Technical Service Bulletin

Date Issued	Model Year(s) Affected	TSB #
9/1/2015	2015, 2016	TSB 427 Recall # 15v-492

Recall Service Bulletin

CONDITION: Hadley control module loss of power

FIG. 2-1

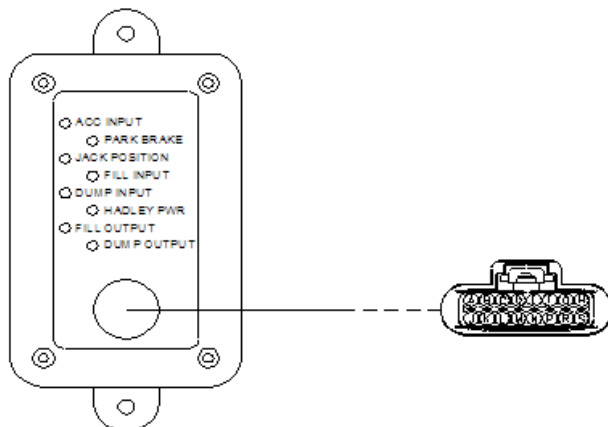
1. Locate Hadley Interface Module in the left front exterior compartment. Refer to FIG. 2-1.

FIG. 2-2

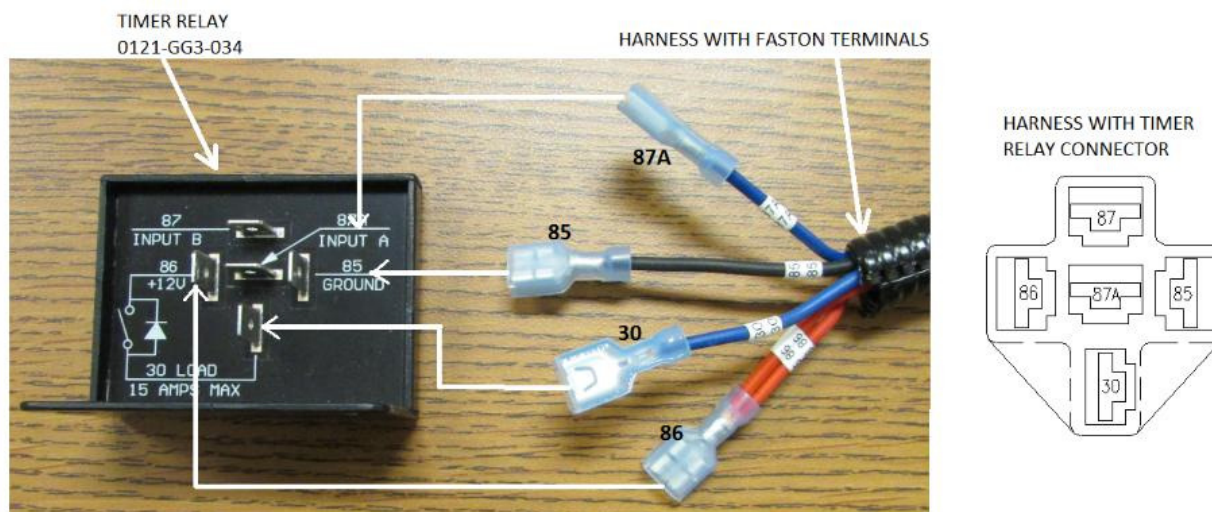
2. Follow harness down and locate connector, approximately 12 inches from module.
3. Slide gray connector lock back, push down on latch, and pull connectors apart.
4. Remove screws securing the Hadley Interface Module to compartment wall and properly dispose of it.
5. Attach 0121-GG3-034 timer relay to the 3900-GG5-002 Hadley relay harness if not already attached (if the harness has single Faston terminals, plug terminals onto the corresponding number as shown on the tag). Refer to FIG. 2-2.

6. Plug in new 3900-GG5-002 Hadley relay harness into connector which was connected to Hadley interface module, and push in gray connector lock.
7. Attach 3900-GG5-002 Hadley relay harness to compartment wall using 2 of the 1007PSTS screws.
8. Attach 0121-GG3-034 timer relay to compartment wall using 2 of the 10075PSTS.
